RE: Data Response, Set 1B
Ivanpah Solar Electric Generating System (07-AFC-5)

**APPLICATION FOR CERTIFICATION
FOR THE *IVANPAH SOLAR ELECTRIC
GENERATING SYSTEM***

Data Response, Set 1B

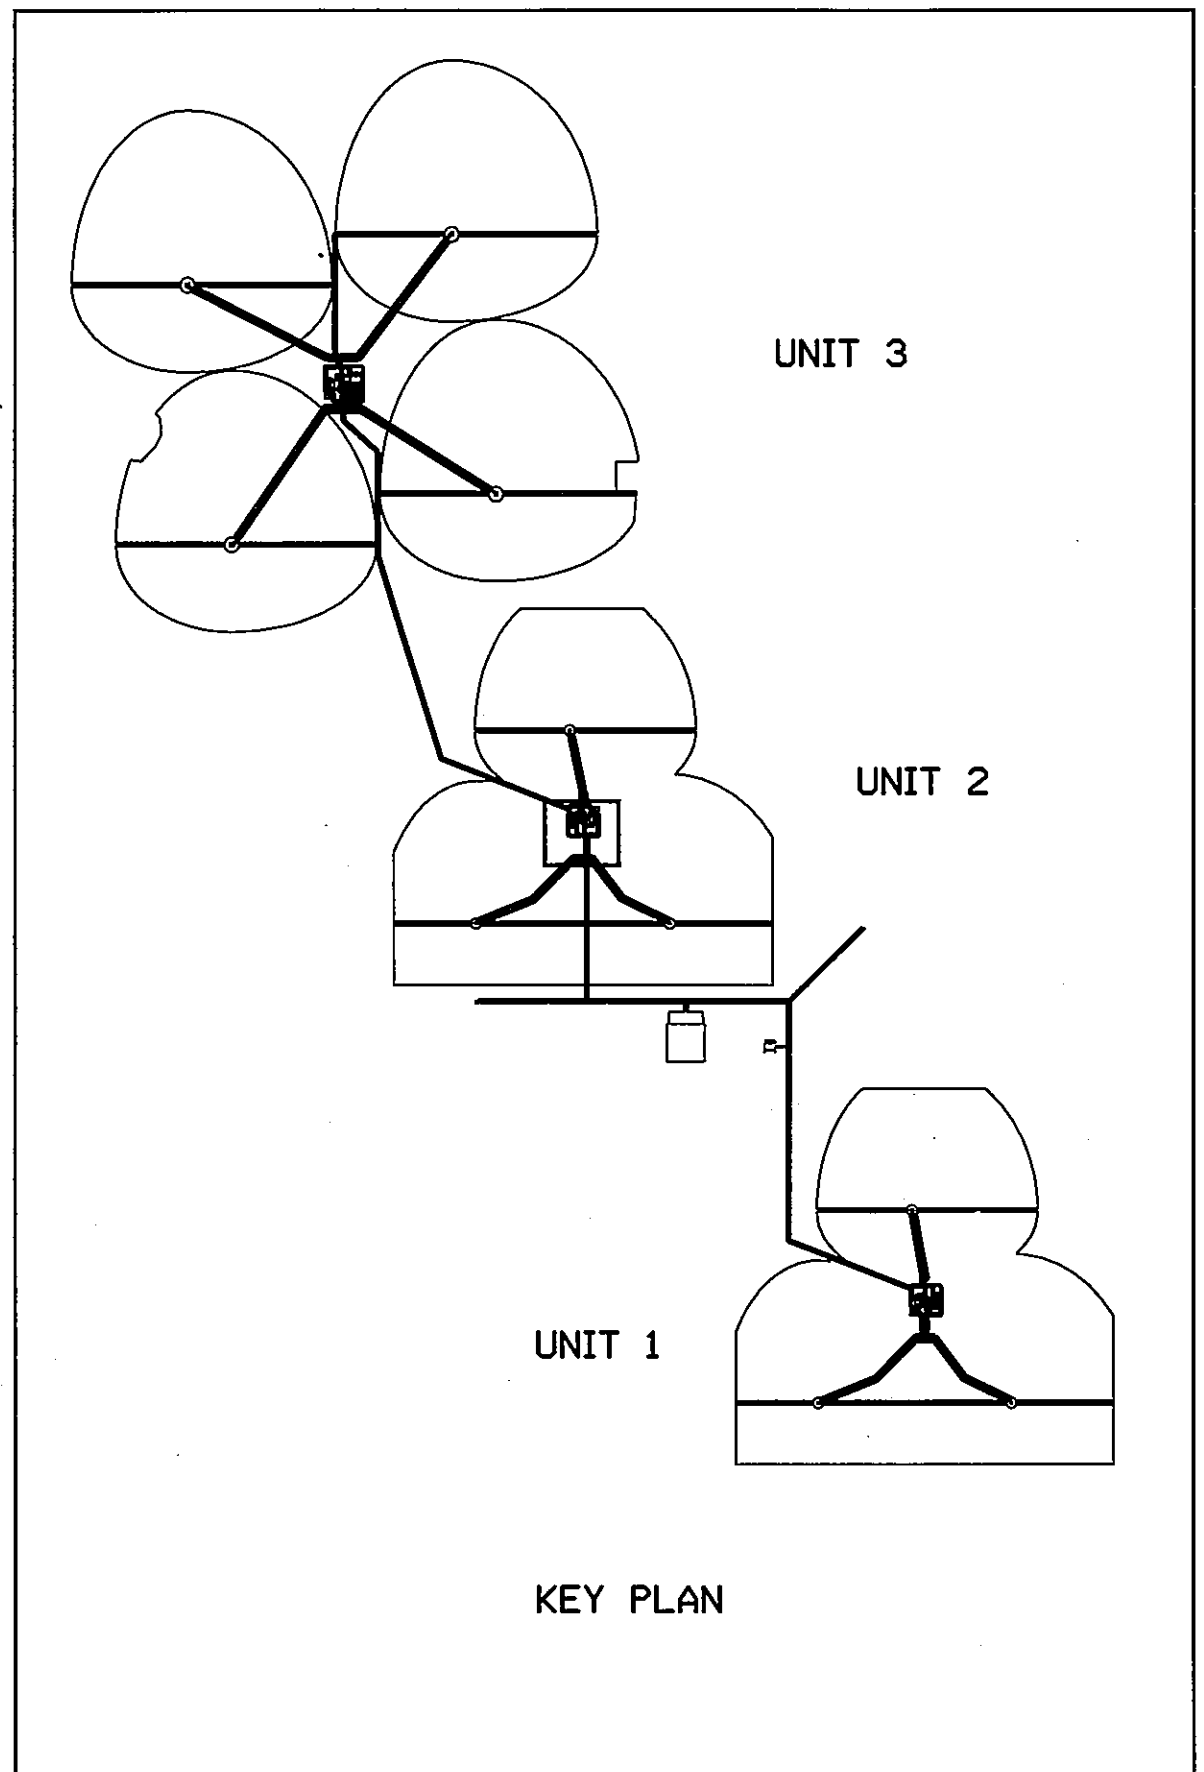
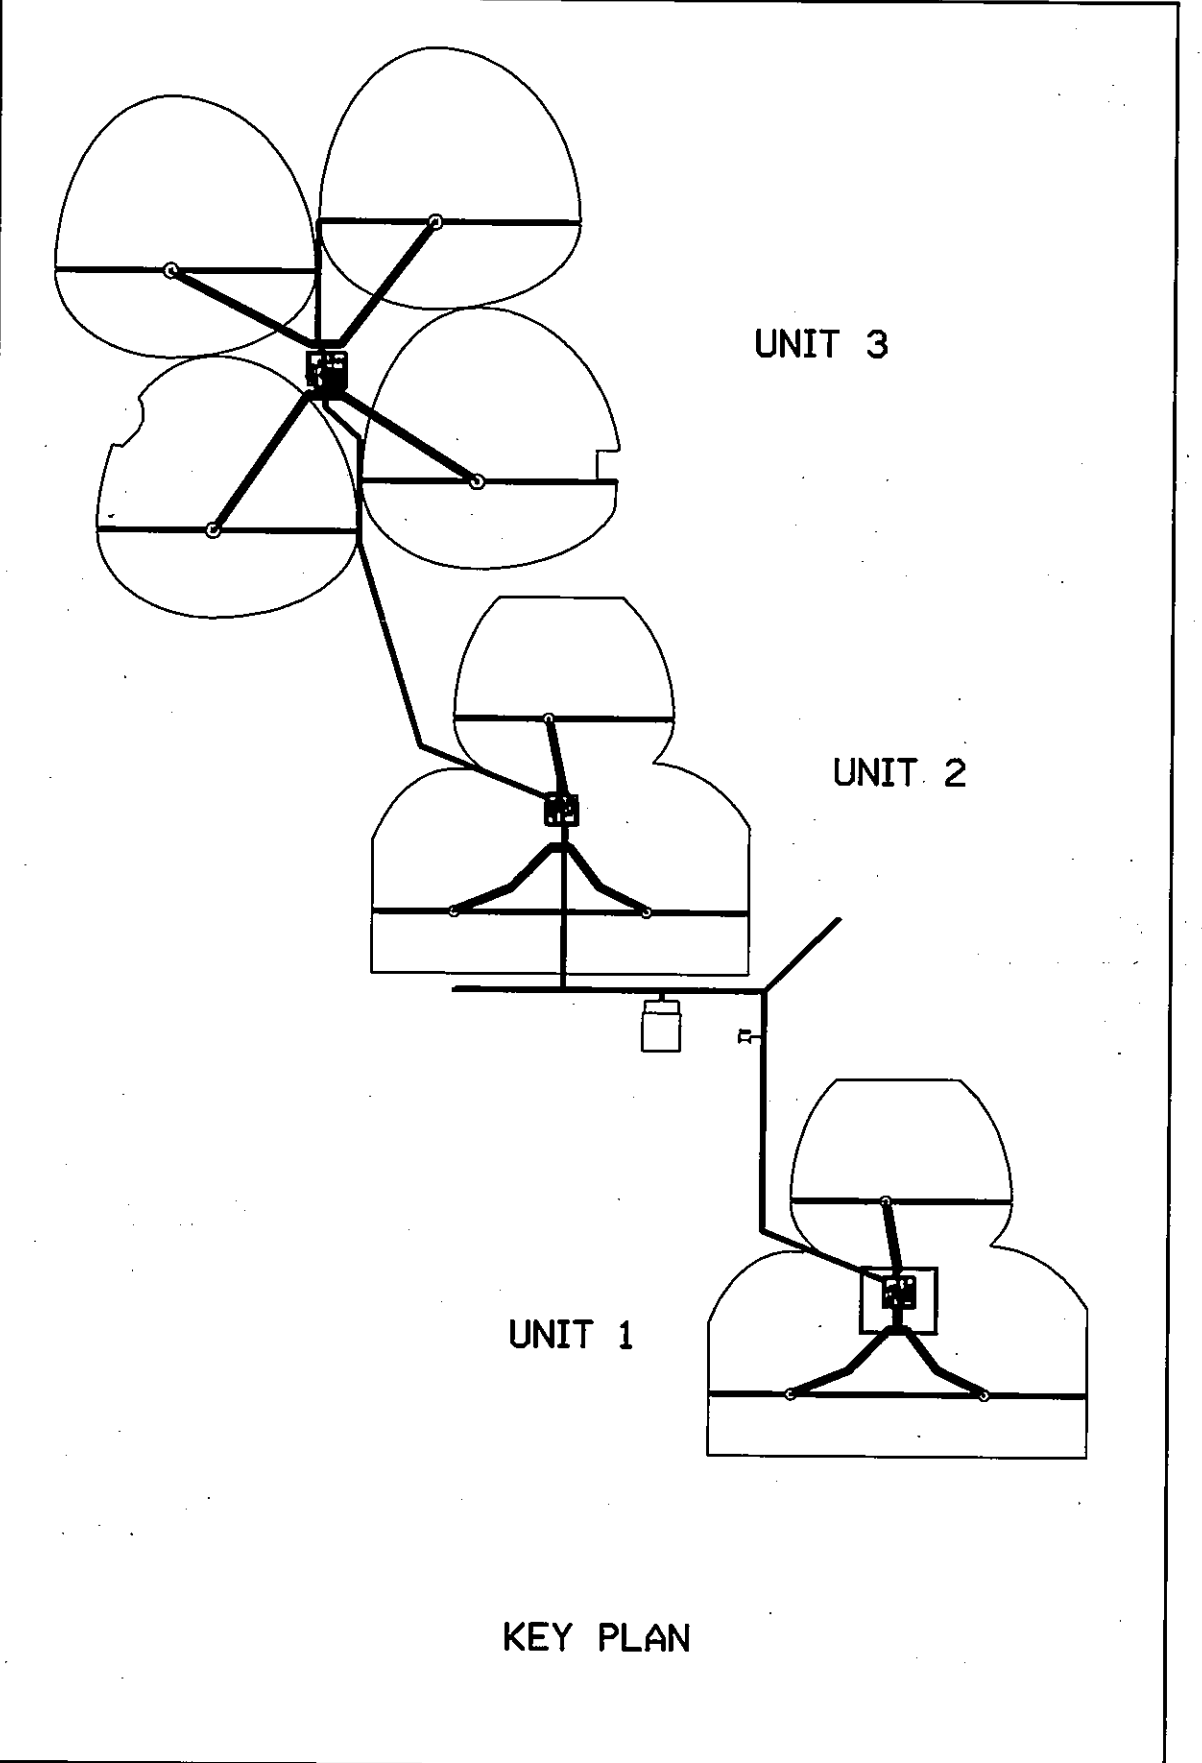
6. Describe and plot spoils storage location, confirming the location would be located within the proposed project footprint or an added acreage.

Response: The spoil storage areas have been designated as shown on drawings Ivan-0-DW112-735-003, Ivan-0-DW-048-735-004 and Ivan-0-DW-048-735-005 (the eight conceptual drawings are provided at the send of this section). Spoil storage areas are to be sited adjacent to each power block located within the proposed project footprint. A brush barrier consisting of native vegetation is to be installed down slope of each spoils storage location to promote sediment deposition.

SCALE 1" = 10'-0"						DRAWING SIZE ANSI E (34" x 44")						
WORLEYPARSONS DWG. NO.						REV						
IVAN-0-DW-048-735-006						A

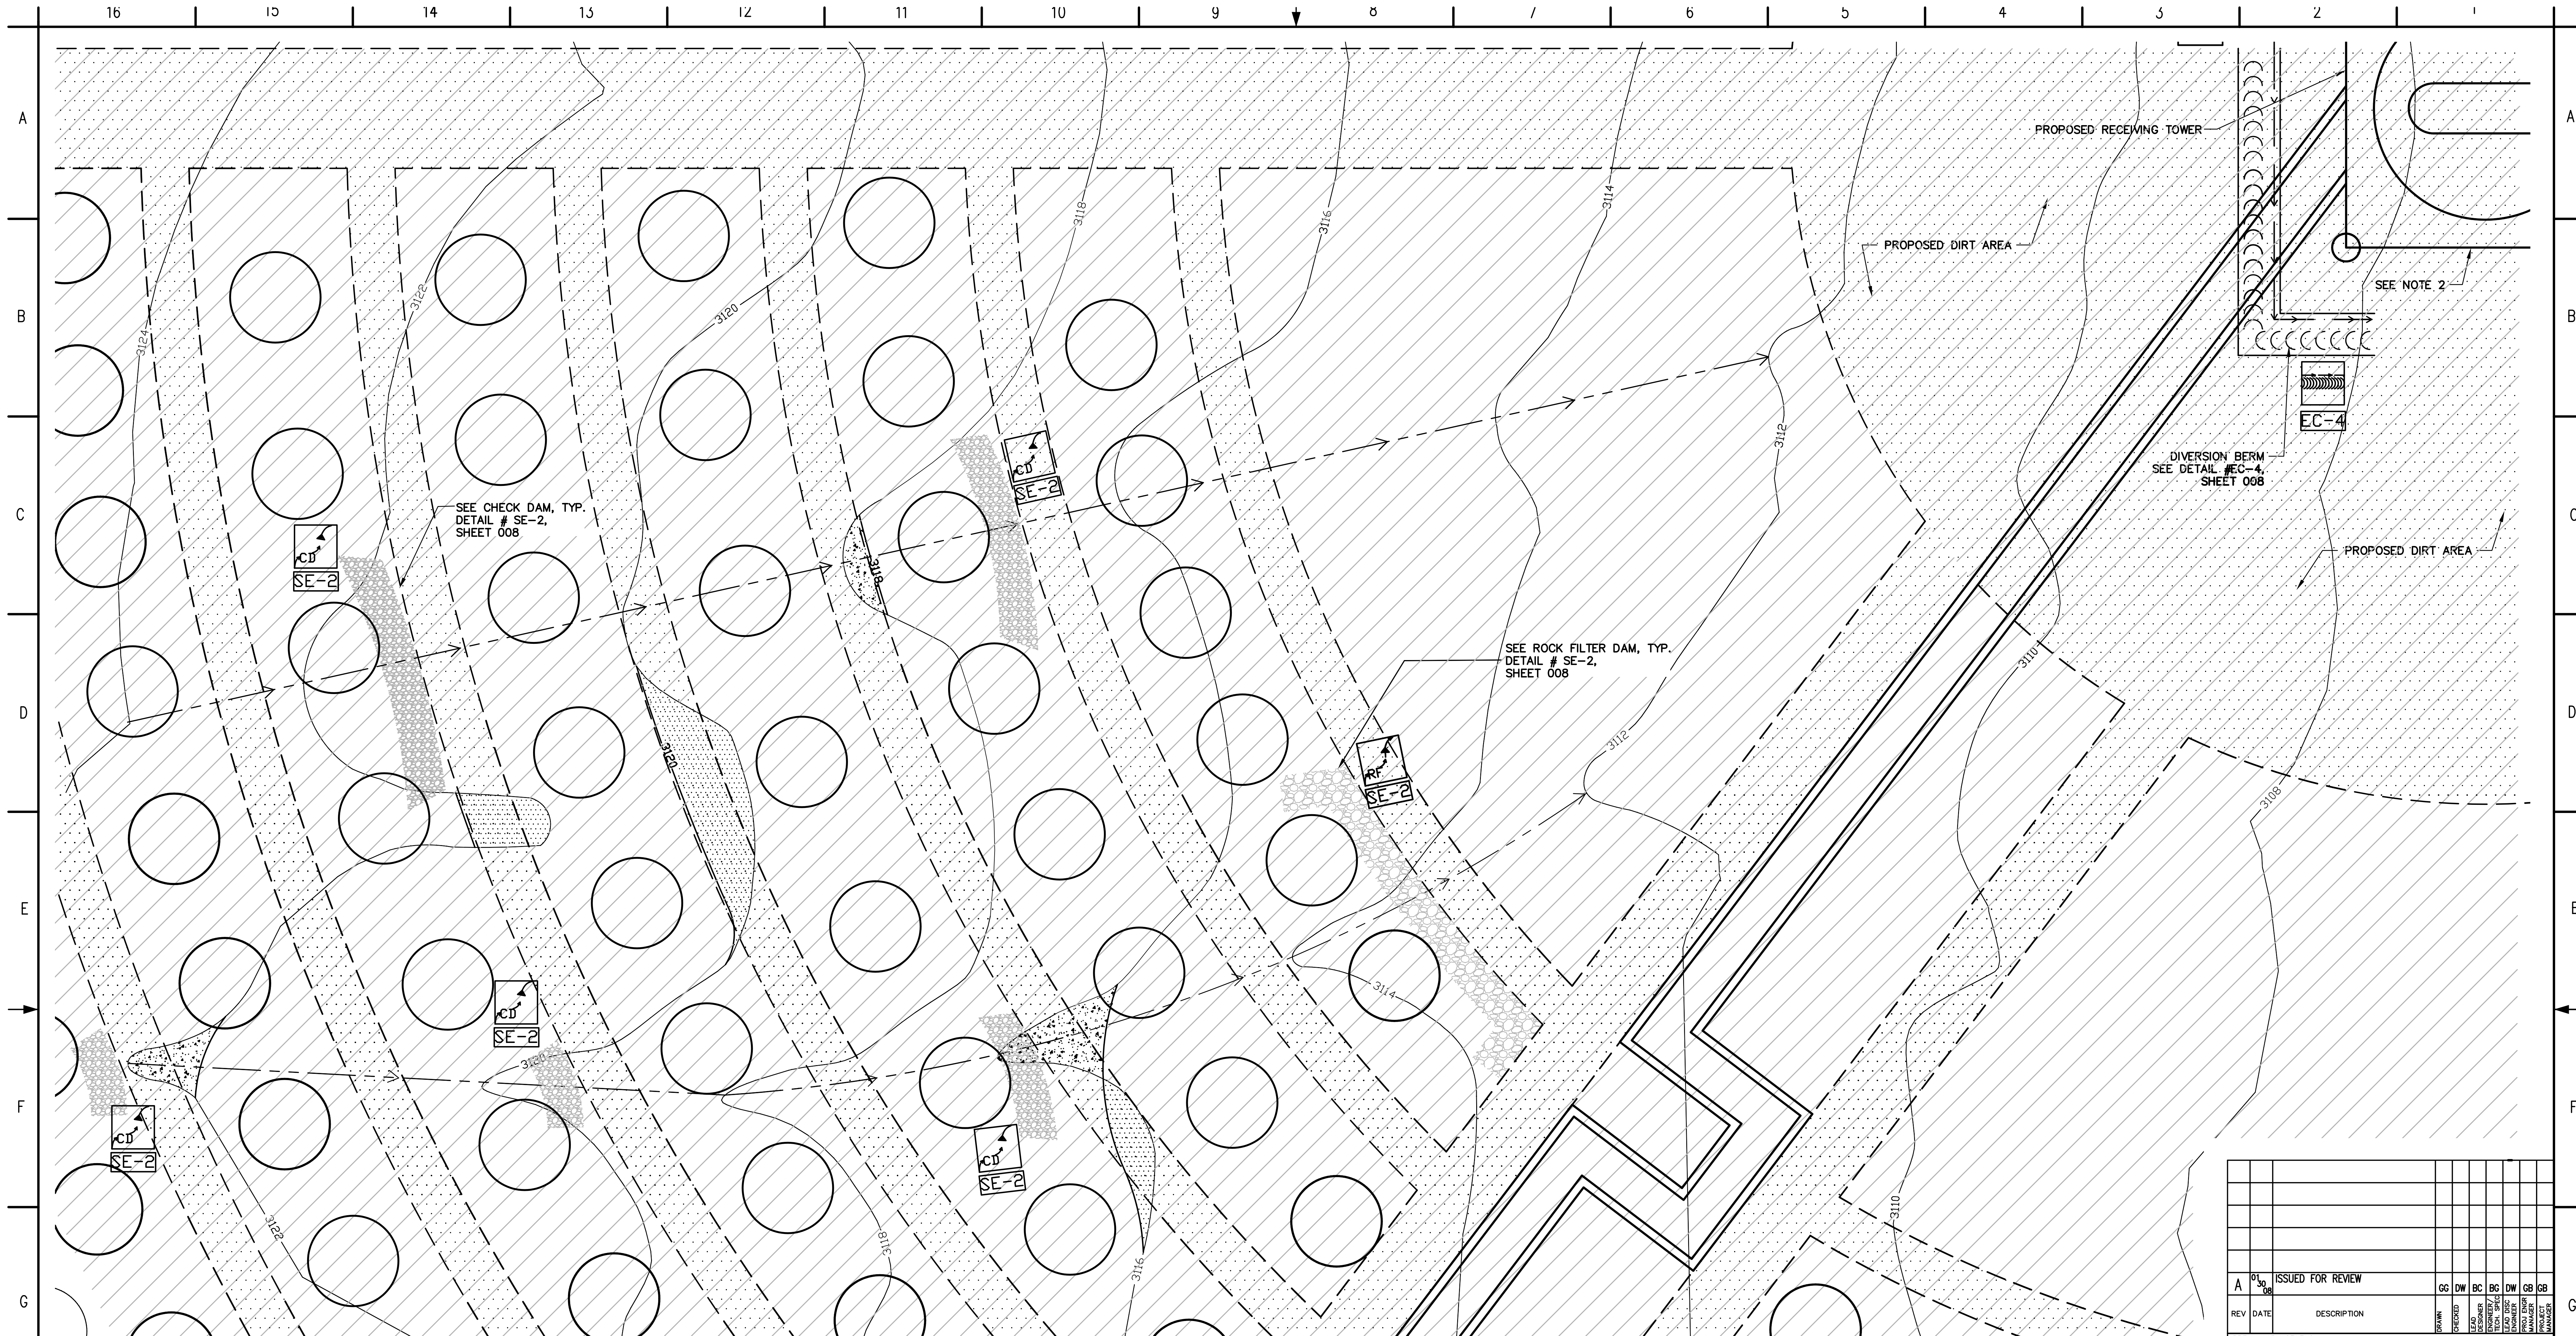
26. Provide a graphic and description of areas of the site that will be graded and areas where root systems will be left in place, and indicate other areas of ground disturbance.

54. Provide an appropriately scaled detailed drawing of the location of all project access routes and indicate whether these are paved, graveled, or graded. This should include the access routes to and between the heliostat mirrors.

Response: See drawings Ivan-0-DW-048-735-001 through Ivan-0-DW-048-735-007 (following Data Response 6). Grading is to be performed only within each of the power block areas, power block connecting road, and re-aligned Colosseum Road. Within the heliostat arrays the surface vegetation is to be removed and the root system is to remain. The proposed dirt access roads within the heliostat arrays will be leveled if required (minor cuts and fills) and only to the extent that minimal access is provided for heliostat installation and maintenance. Drawings Ivan-0-DW-048-735-006 and Ivan-0-DW-048-735-007 (following Data Response 6) have been created to provide

Response: The location and types (paved, graveled or graded) of project access routes have been provided in project drawings Ivan-0-DW-048-735-001 through Ivan-0-DW-048-735-007 (following Data Response 6). Roads connecting all three power blocks will be graded and paved including the re-routed Colosseum Road. The proposed dirt access roads within the heliostat arrays will be leveled if required (minor cuts and fills) and only to the extent that minimal access is provided for heliostat installation and maintenance. Drawings Ivan-0-DW-048-735-006 and Ivan-0-DW-048-735-007 have been created to provide additional clarity regarding typical areas of disturbance within the heliostat array fields.
